CITY OF ALBUQUERQUE

**RE: Coors Pavilion Lots 2 and 3
9154 Coors Blvd
Request for Certificate of Occupancy
Hydrology Final Inspection- Not Approved
Engineer's Stamp Date: 5/31/2017 (G11D069A)
Certification Dated: 11/4/2017**

Re: G11D069A – Lots 2 & 3 Coors Pavilion Subdivision Drainage Certification

CITY OF ALBUQUERQUE
PUBLIC WORKS DEPARTMENT
ENGINEERING DEVELOPMENT GROUP
COORS PAVILION SUBDIVISION
LOTS 2 & 3
GRADING & DRAINAGE PLAN

DRB No. CITY PROJECT No. ZONE MAP NO. **G-11-Z** **C-101**

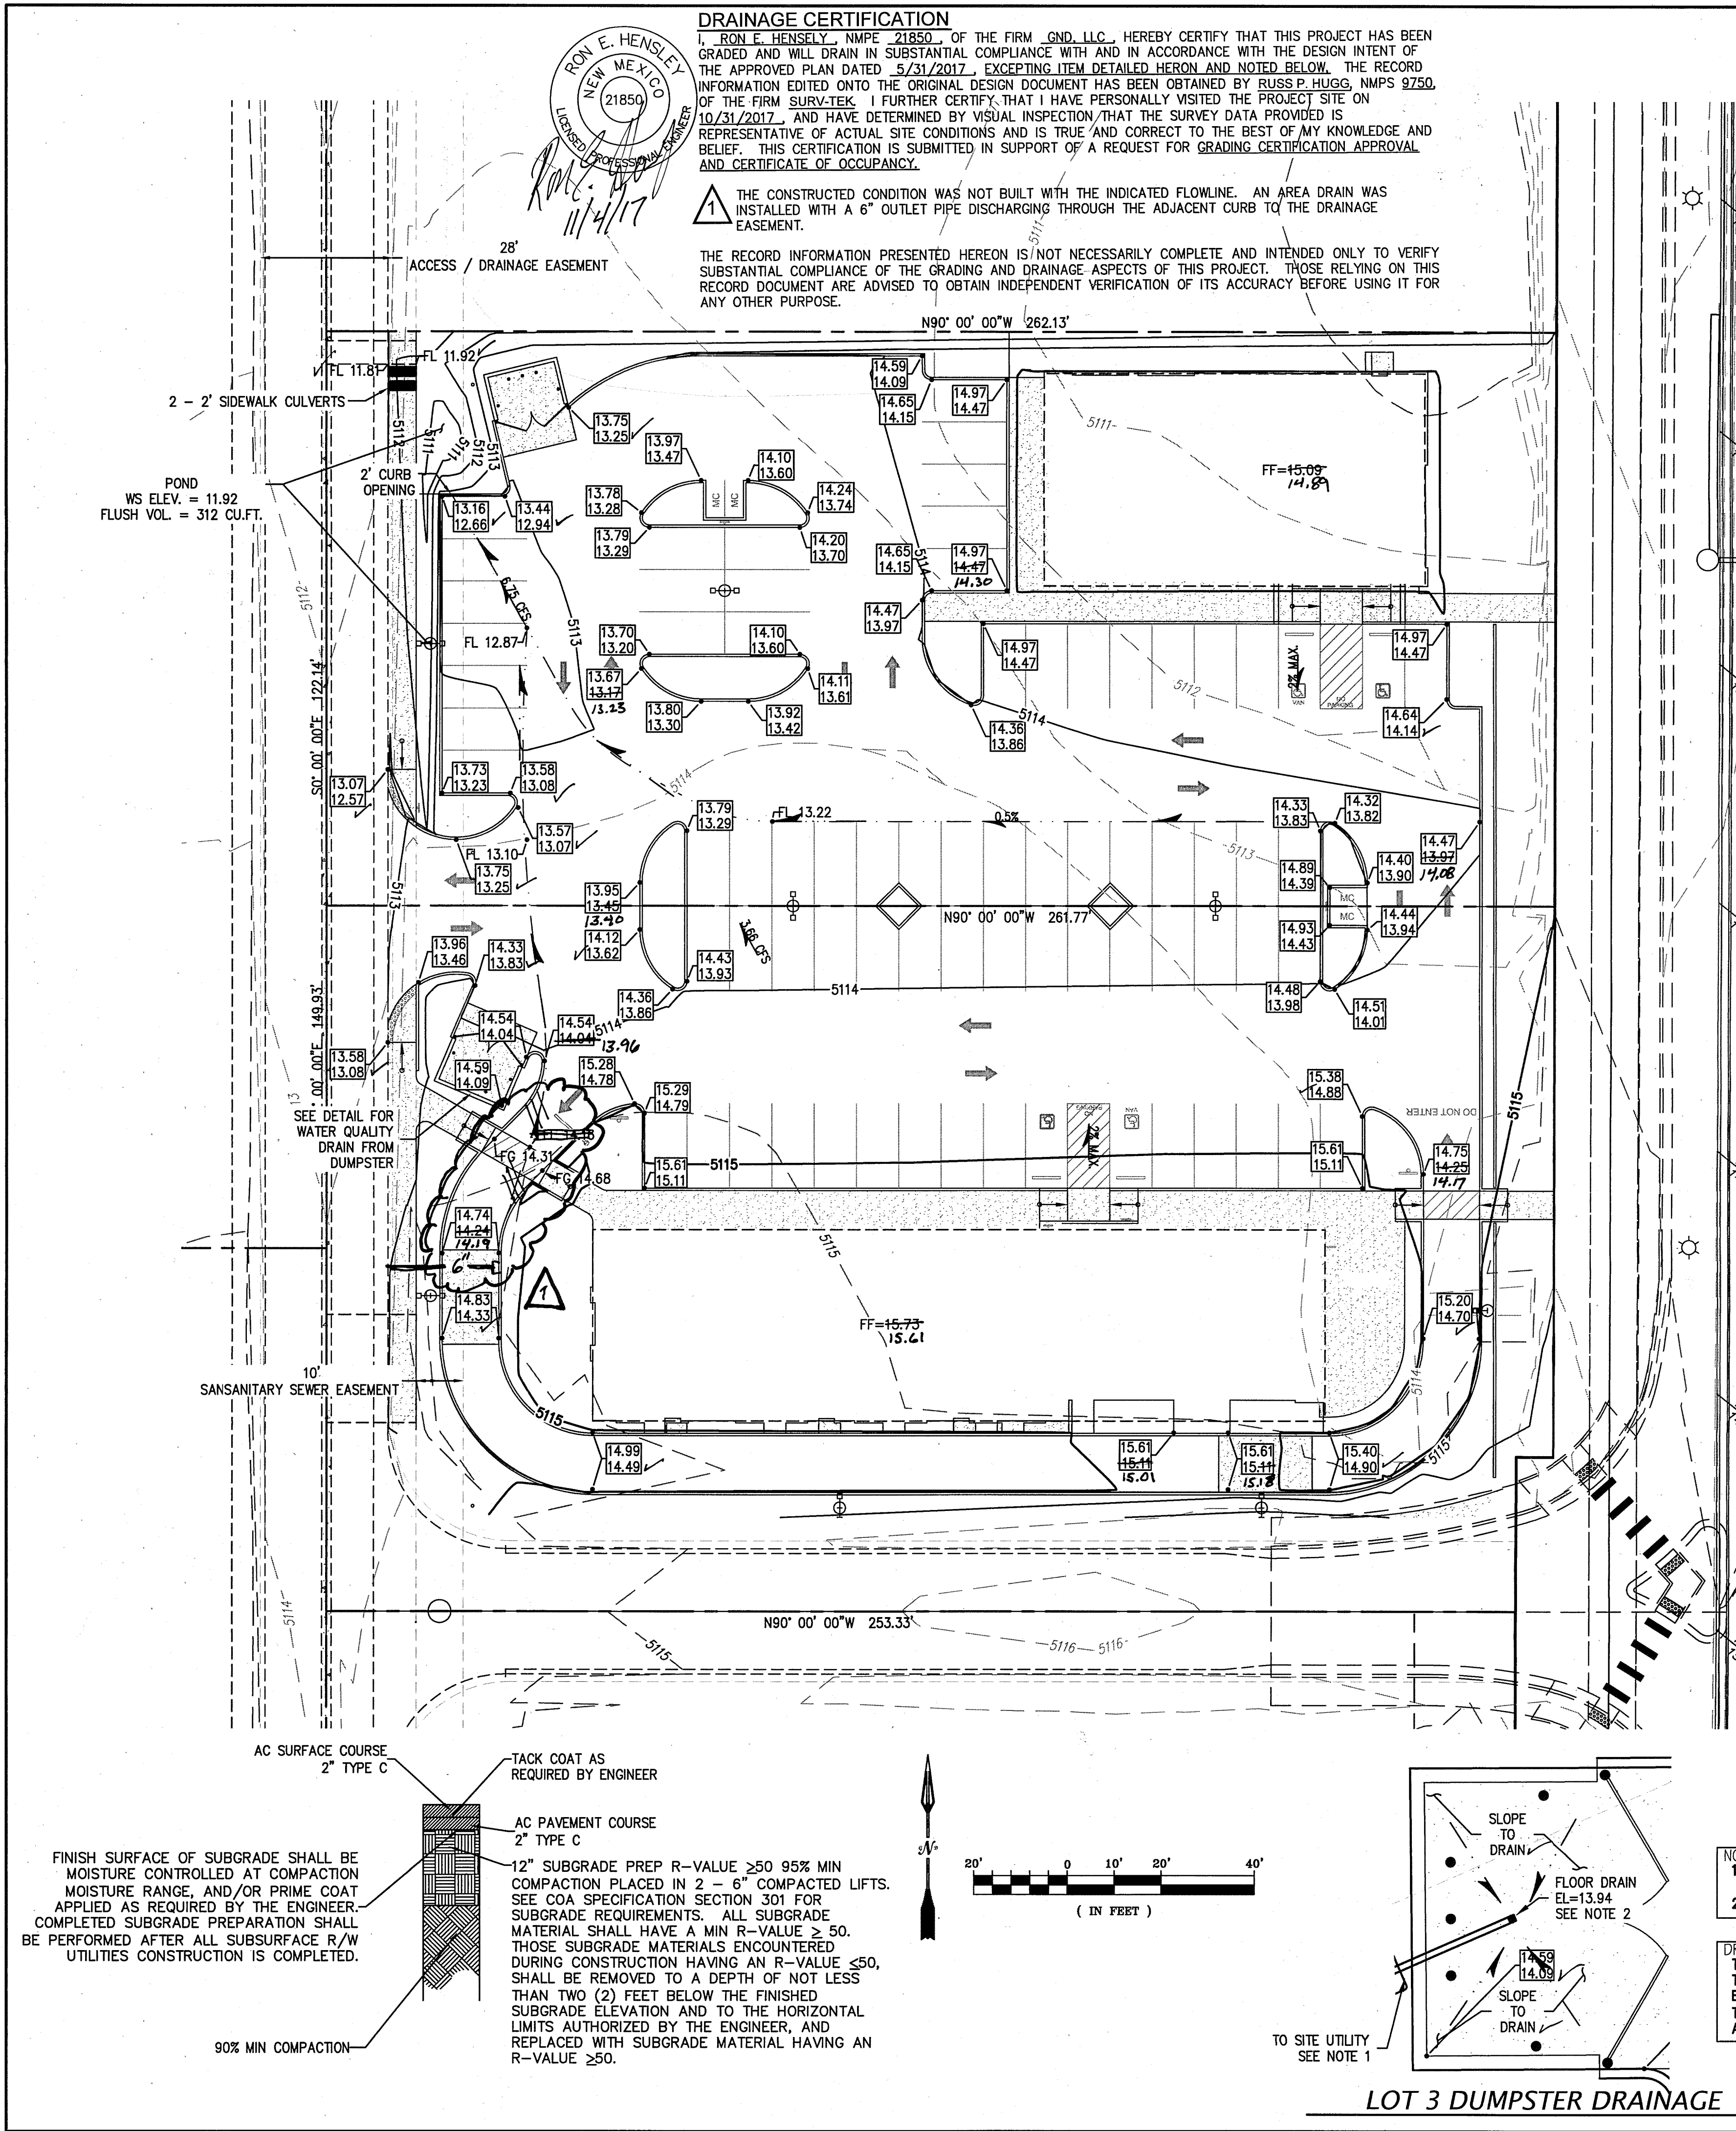
Based on the information provided in your submittal received 11/7/17, this submittal cannot be approved for release of Certificate of Occupancy by Hydrology until site construction on these two lots is complete. Once construction is complete, constructed site conditions will need to be documented on the certification and a new submittal made. In addition, the following condition of Building Permit approval, dated 6/1/17, must be complete prior to requesting C.O:

- Prior to CO, a Private Facility Drainage Covenant for the Coors Pavilion Subdivision pond will be required.

The original notarized covenant, exhibits, and recording fee (\$25, payable to City of Albuquerque) must be turned into DRC (4th, Plaza del Sol) for routing and recording. Please contact Charlotte LaBadie (clabadie@cabq.gov, 924-3996) or Madeline Carruthers (mtafoya@cabq.gov, 924-3997) regarding the routing and recording process for covenants. If you have any other questions, contact me at 924-3695 or dpeterson@cabq.gov.
